From: [REDACTED]
Sent: 01 December 2025 17:51
To: Anna Tidey
Subject: Re: Planning application - DM/25/2311 Llain, 4 Nostel Priory Cottages, Balcombe
Attachments: Garden House.jpeg; Future Cladding (on approval).JPG; Mock up - Llain.png; Fable & Bloom - Black frames.jpg; Hedgerow Removal Enquiry.pdf

Subject: Planning application - DM/25/2311 Llain, 4 Nostel Priory Cottages, Balcombe

Rehau R7 Residence window in white foil grained finish

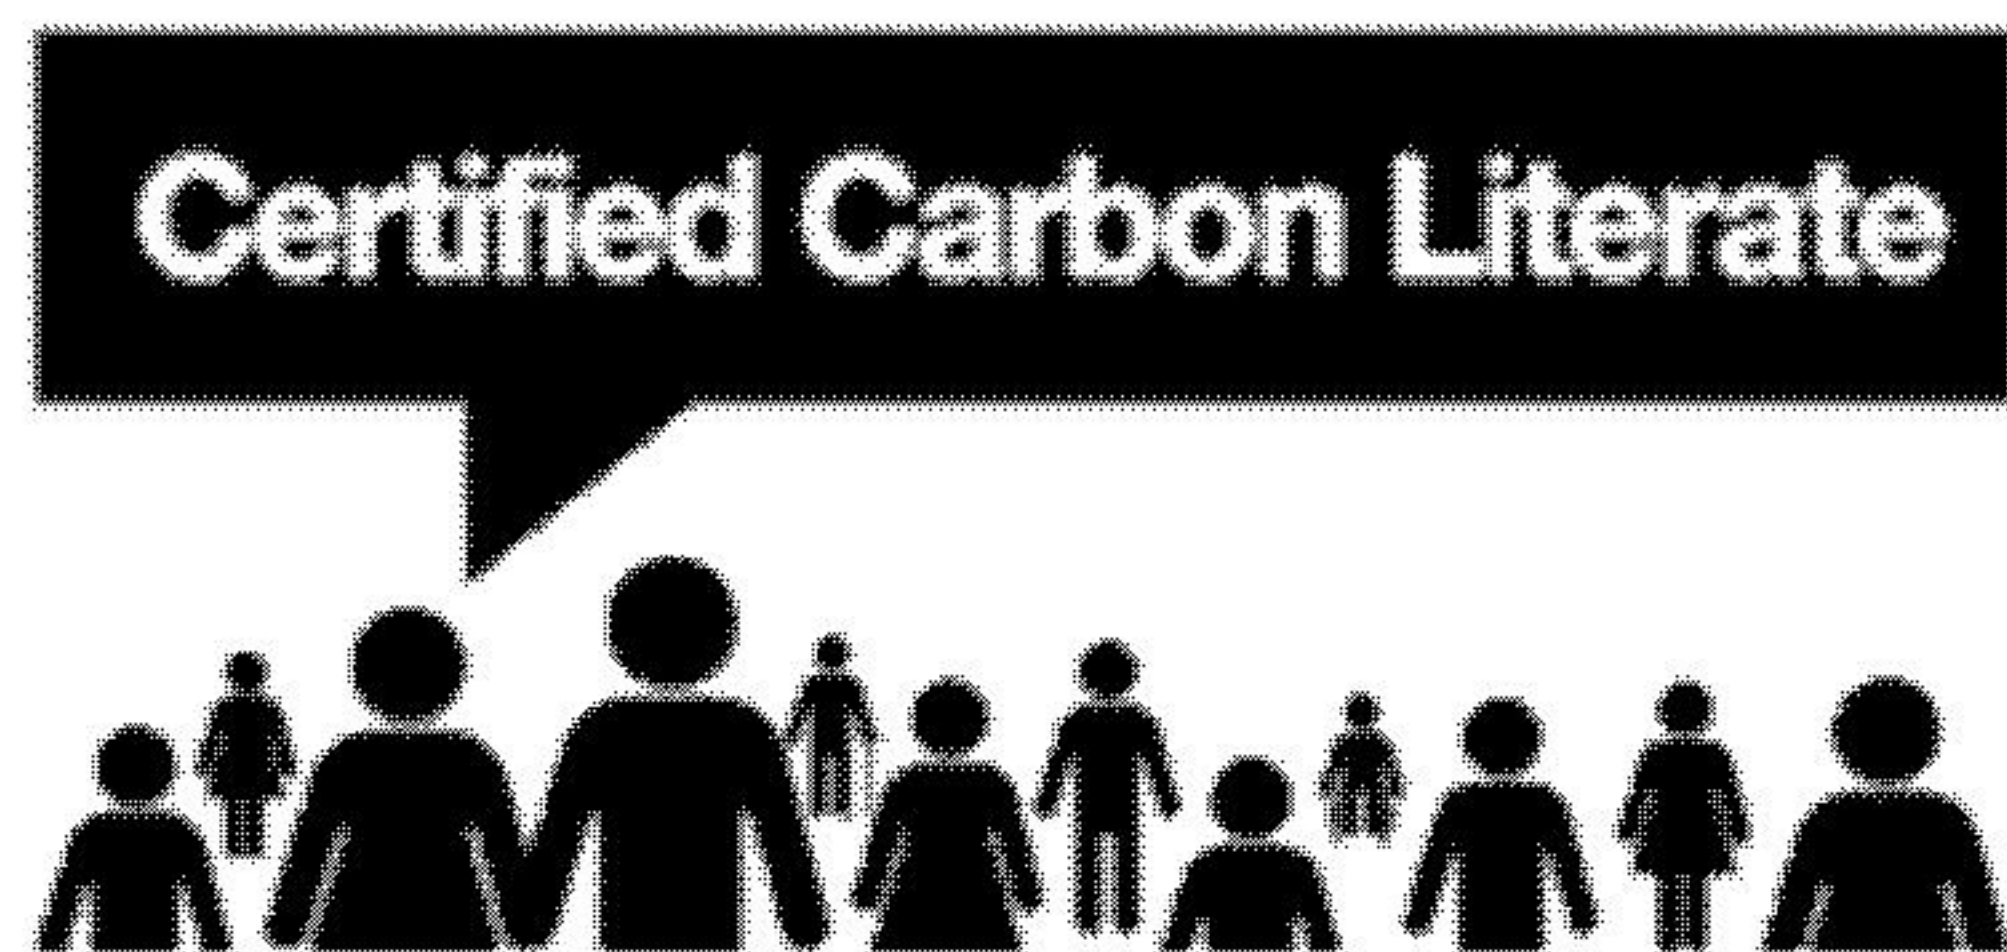
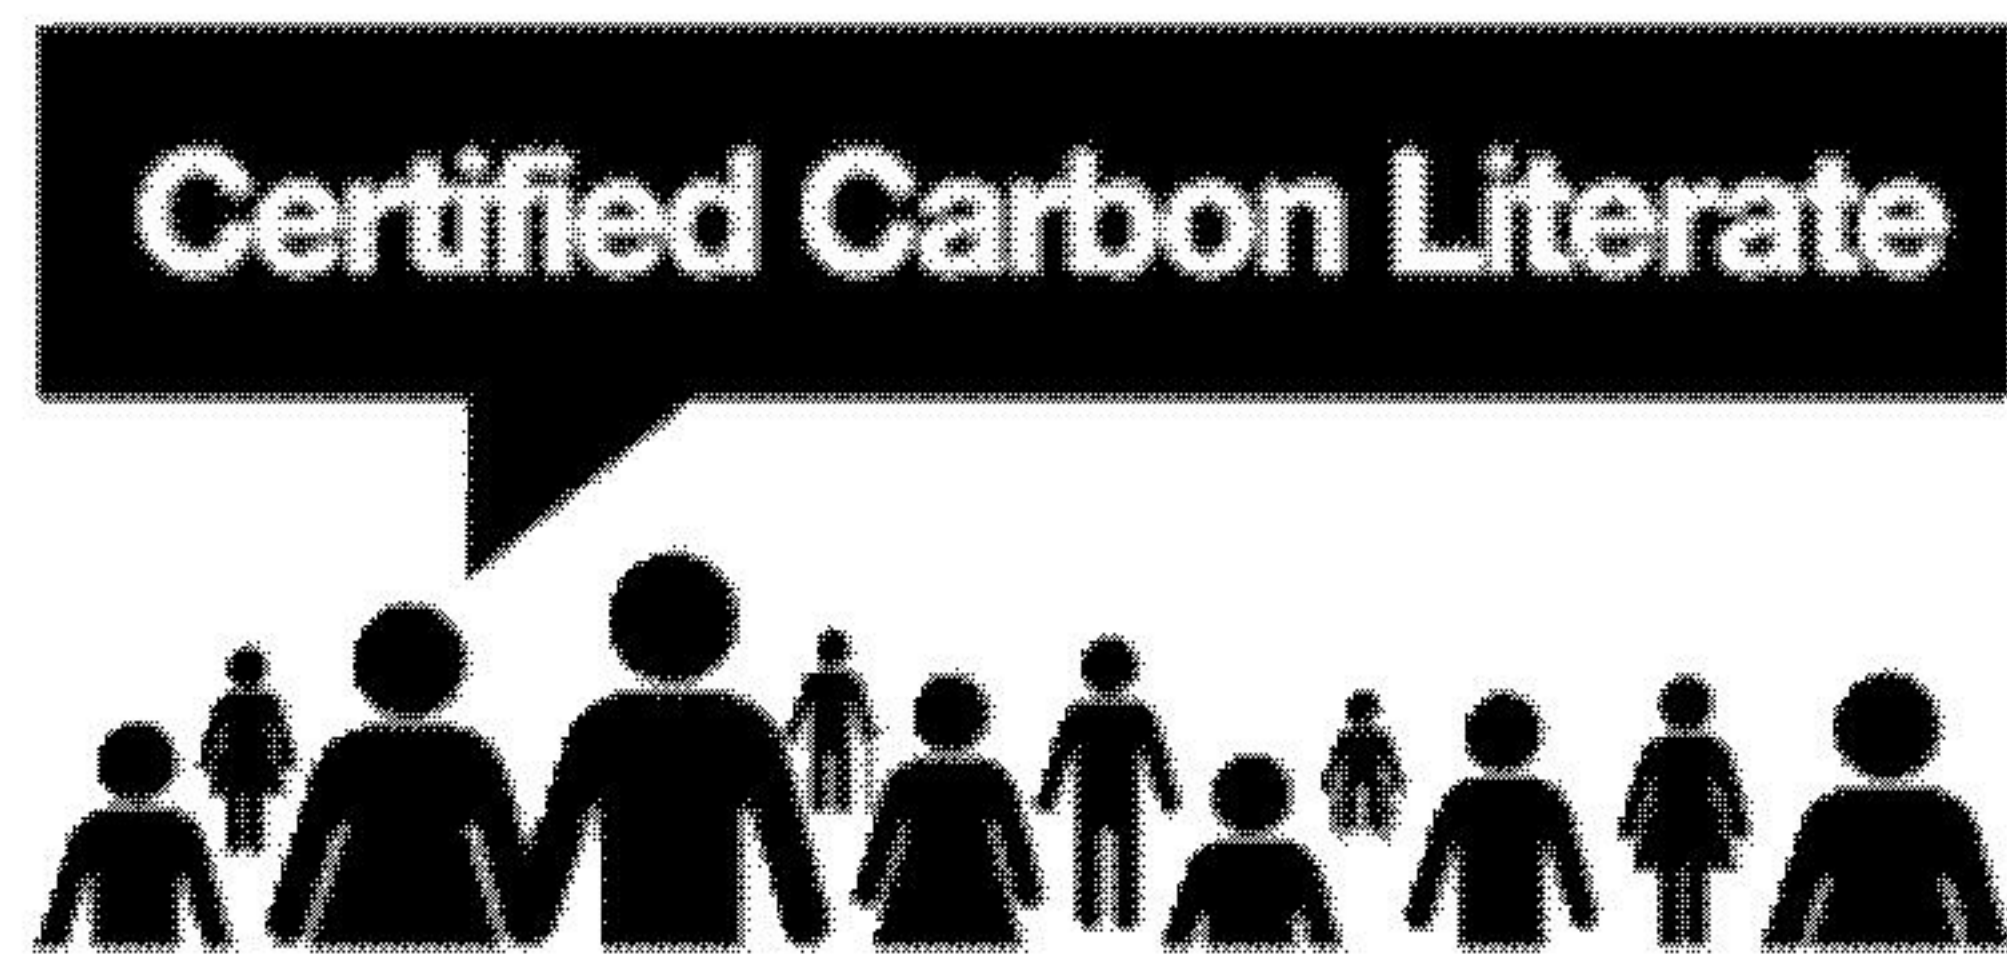
I mentioned another application at a house in Cuckfield where I have determined an application for replacement windows (Howdean, High Street, Cuckfield, under application DM/25/1690). In that case the house is located in a prominent position fronting the High Street and had shiny white UPVC replacement windows already installed. The Conservation Officer comments for that application are attached, for your information. Below I have reproduced the image and website link details for the white windows with a foil grained finish which were approved in that case, for your information.

Each planning application is determined upon its merits and in that case the proposed new windows were accepted as a replacement for white UPVC windows that had been installed without consent.

I understand that you will want to think about the comments that have been made, and ask that you reply to me by the end of the week to explain how you would like to take this matter forward. I would like you to reconsider the window colour and materials to reflect the immediate context of your house and the other neighbouring dwellings in the Conservation Area.
